UNITED STATES PATENT AND TRADEMARK OFFICE

APPLICATION NO.	FILING DATE	FIRST NAMED INVENTOR	ATTORNEY DOCKET NO.	CONFIRMATION NO.
10/802,984	03/17/2004	Donald R. Van Der Moere	D5270	3898

Office Action Summary

DETAILED ACTION

FIG. 1
PRIOR ART

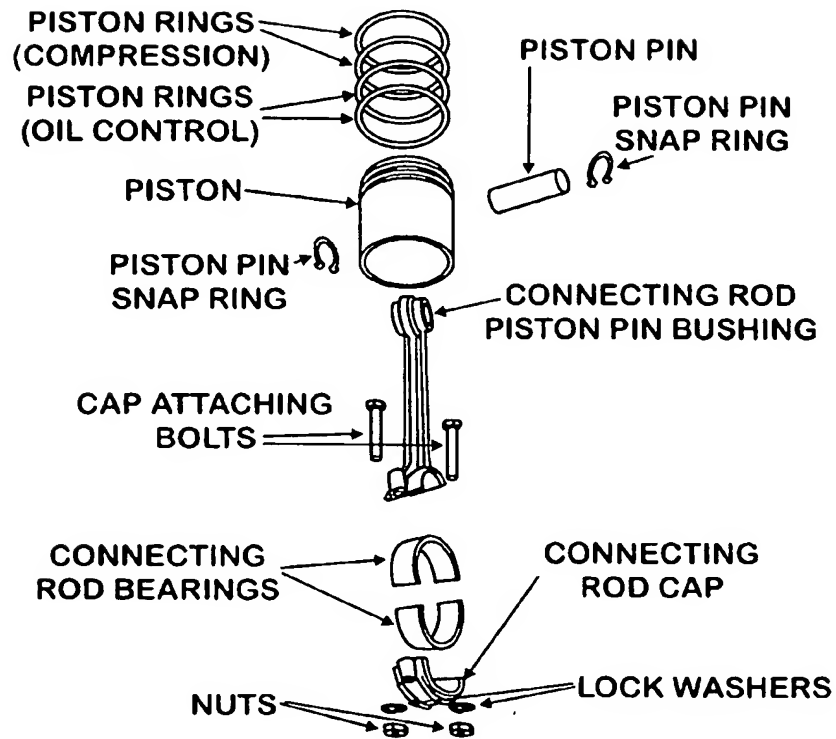
The drawings were received on September 28, 2004. These drawings are not acceptable. The drawings do not comply with 37 CFR 1.121 because the top margin of each sheet has not been identified as "Replacement Sheet".

not accepted
92. 8/4/05

FIG. 3b
PRIOR ART

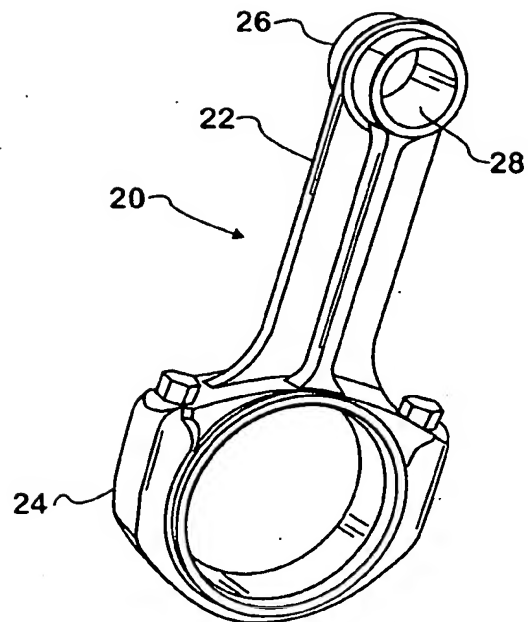
not accepted
GL, 8/4/05

FIG. 6

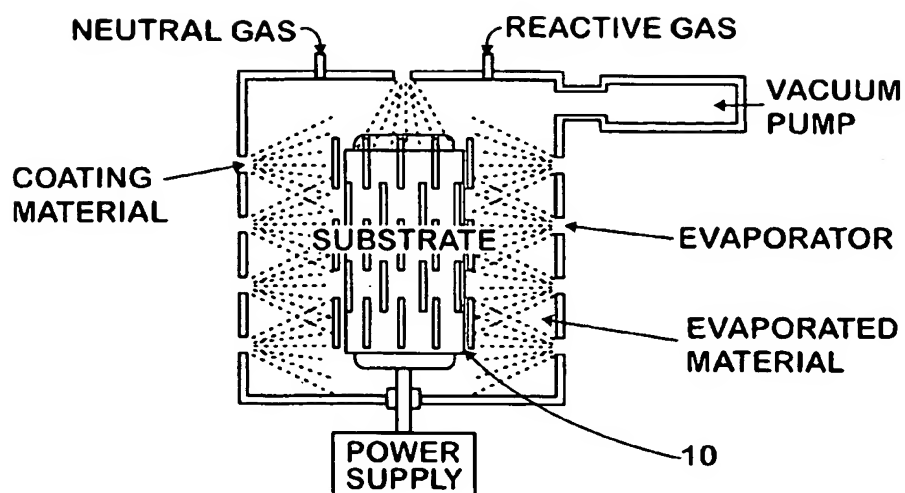
not accepted
E.L. 8/4/05

FIG. 7

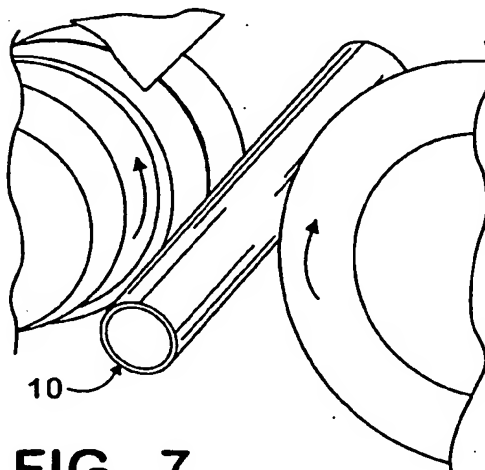
not accepted
A.L. 8/4/05
